**GENOA CHARTER TOWNSHIP
PLANNING COMMISSION PUBLIC HEARING
SEPTEMBER 10, 2018
6:30 P.M.
AGENDA**

Attention:	Kelly Van Marter, AICP Planning Director and Assistant Township Manager
Subject:	Dog Town/Kitty City – Special Land Use and Site Plan Review #2
Location:	3557 East Grand River Avenue – north side of Grand River, east of intersection with Grand Oaks Drive
Zoning:	GCD General Commercial District

**Re: Dog Town and Kitty City, LLC
Site Plan Review**

Attention:	Kelly Van Marter, AICP Planning Director and Assistant Township Manager
Subject:	Volunteers of America –Sketch Plan Review #1
Location:	2700 E. Grand River Avenue – south side of E. Grand River, east of Chilson Road
Zoning:	GCD General Commercial District

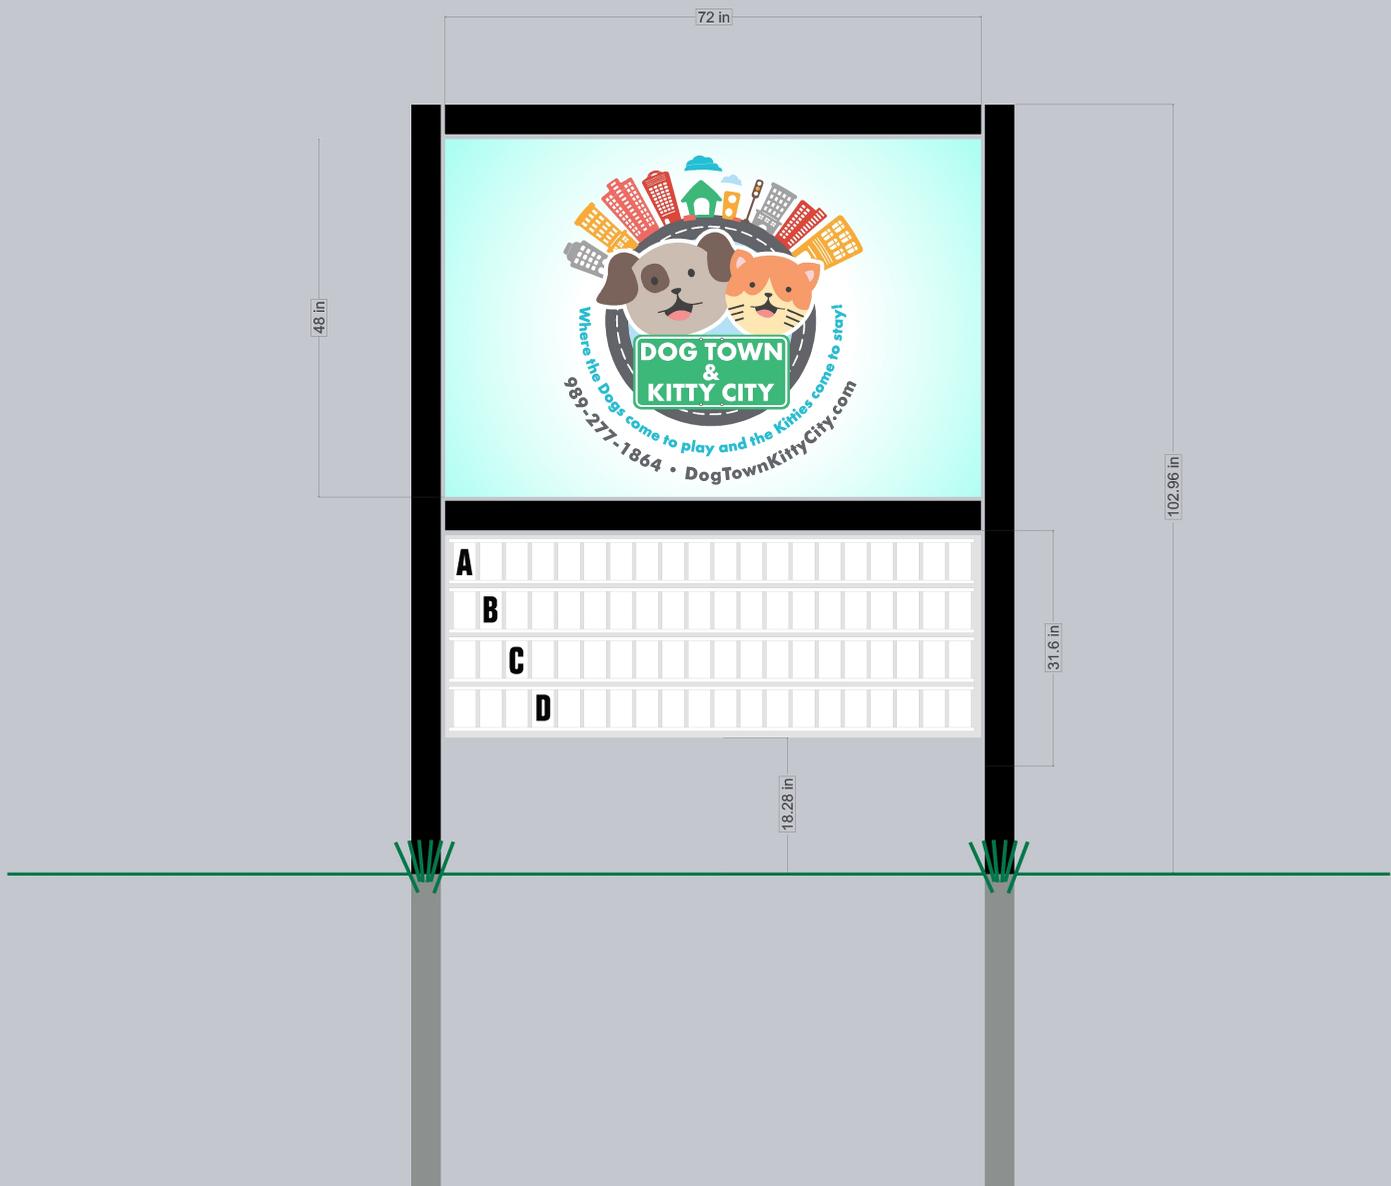
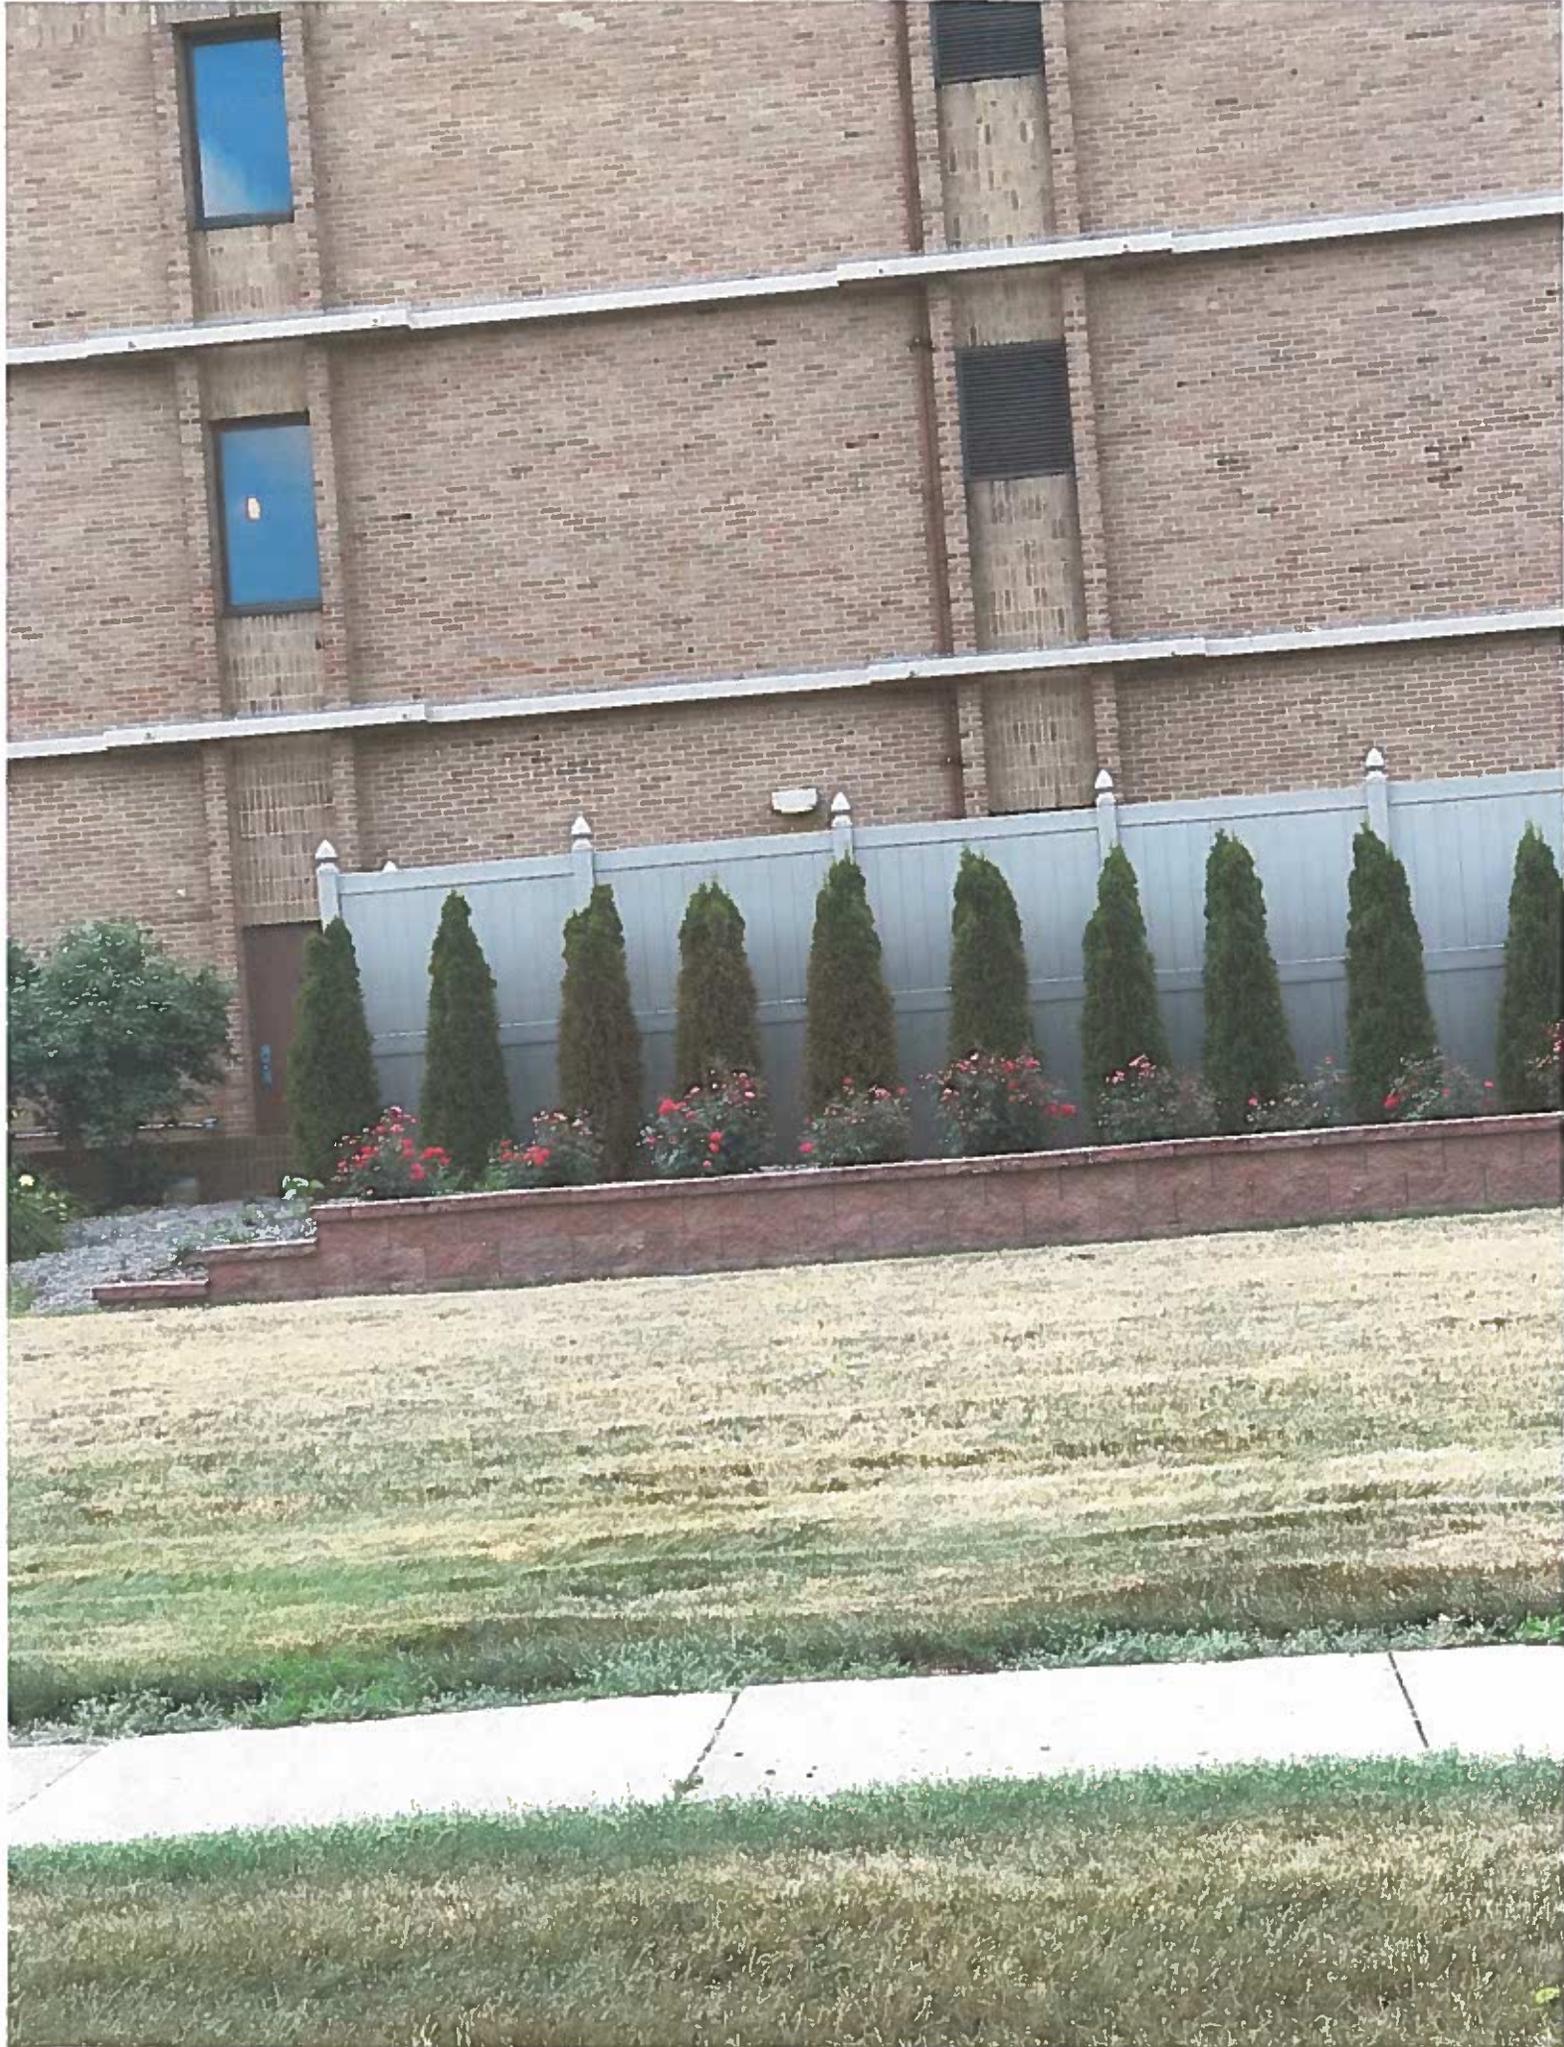
The revised submittal does include a detail of the proposed pole sign replacement, depicting an approximately 8.5-foot tall sign structure with a 24 square foot sign and an additional 12 square feet (approximately) of changeable message copy.

**PET DAYCARE
SITE PLAN**
PET DAYCARE
GENOA TOWNSHIP

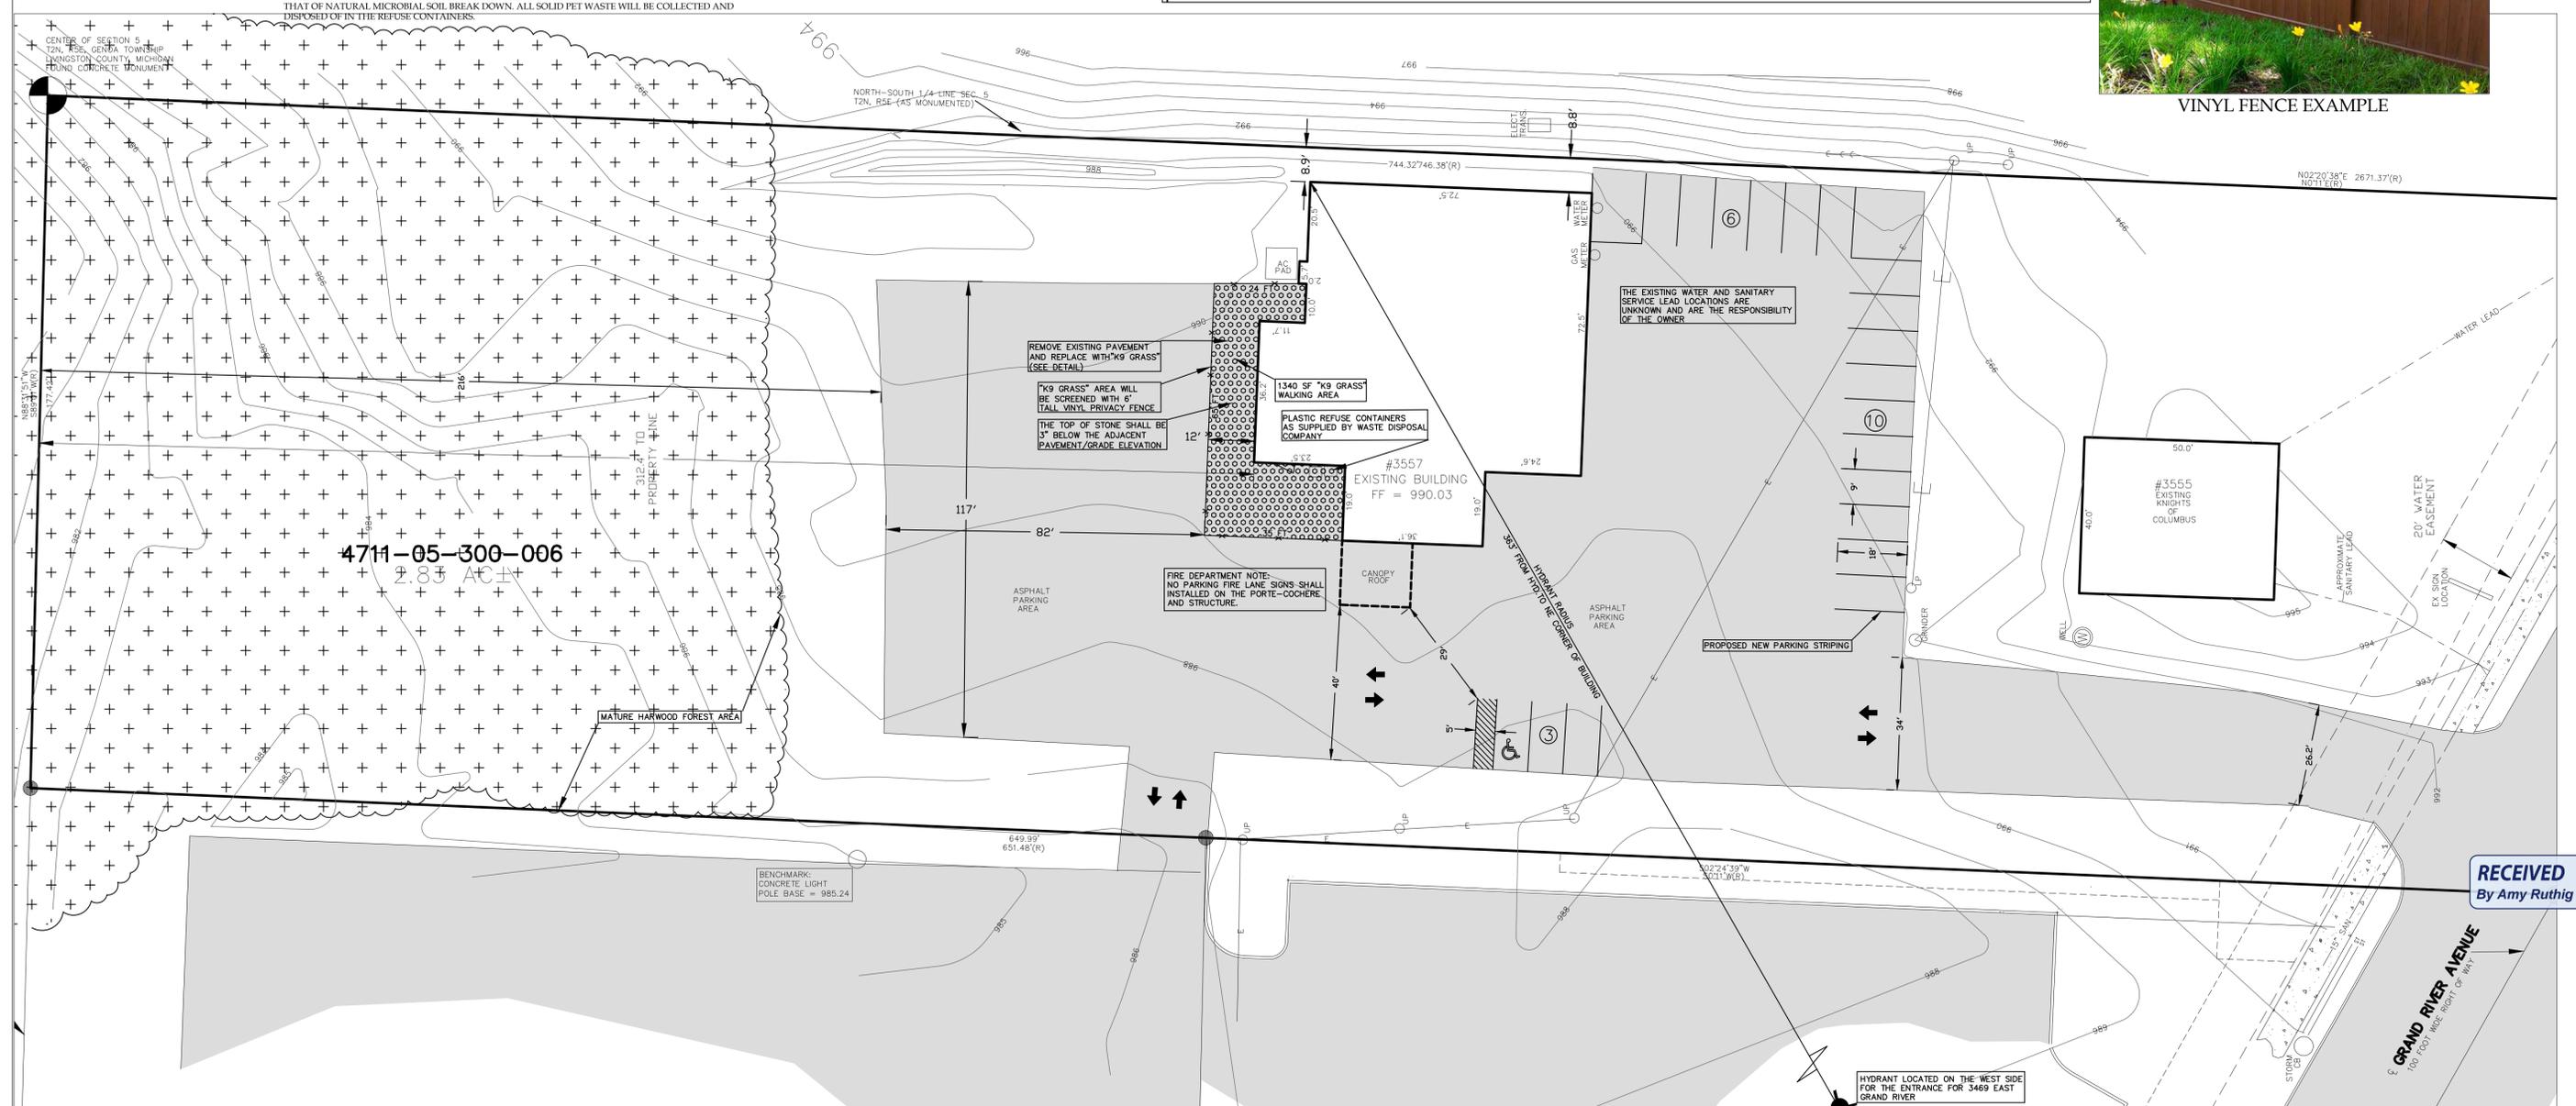
1. Site note 1 describes a wood privacy fence being installed; this should be updated to note the correct fence type.

1. The existing well raises cross-contamination concerns. A note should be included on the plans to properly abandon the existing well.
2. The following notes should be added to the plans:
 - a. The private sanitary lead between the building and grinder pump is not shown.
 - b. The building is served by a private water lead from the southern building, the private water lead between the two buildings is not shown on the plans.

1. North compass orientation is incorrect, and is facing East. **(This has been revised on the drawings)**
2. Although scale is provided, provide parking lot and drive dimensions on site plan. **(Dimensions have been provided for the parking area and appear to be in compliance with clear required widths.)**

3. Provide the location of the nearest fire hydrant to the structure on the site plan. It is believed there is a hydrant at or near the entrance to the drive that is to be shown. A hydrant shall be provided with 400' hose-lay of all parts of the building, show this distance from the hydrant. This hydrant is required to provide fire flow for the structure and with the level of alteration to the existing building and potential distance exceeding 400, and additional hydrant may be required. **(Based on the provided information, the nearest fire hydrant falls outside of the required 400' hose-lay distance from the nearest hydrant. To meet the requirement, a hydrant needs to be added on the property. The level of alteration to the building warrants this requirement. A hydrant installed within the existing water main easement will place the facility within the 400'.)**

4. Provide fire apparatus access lanes at a minimum of 26. from entrance and throughout, with exception of the area adjacent to the porte-cochere (no less than 20'). This 26' width is encroached upon by the first 4 parallel parking spaces on the entrance drive, requiring their relocation/elimination. **(Parallel parking spaces have been removed improving entrance clear width and parking has been rearranged near the porte-cochere to improve width in that area. A concern noted is that all other parking spaces have been eliminated from the drawing to the North. Parking spaces or identified access drives need to be identified on this portion of the parking lot. See item 5, related to emergency vehicle circulation.)**

5. Provide an emergency vehicle circulation plan showing vehicle access and turnaround capabilities. **(This item has technically been addressed by the elimination of the parking spaces at the north end of the parking lot, however, this creates a greater problem. Without designated drive aisles and parking spaces, emergency access and turnaround can quickly become hindered by parked vehicles. Reassignment of parking spaces must be shown with proper width access drives and vehicle circulation.)**

6. Provide fire apparatus access fire lane markings along the west side of the building on columns of the porte-cochere and structure. **(With the parking rearrangement the south side of the building is open and needs to be signed as a fire lane as well.)**
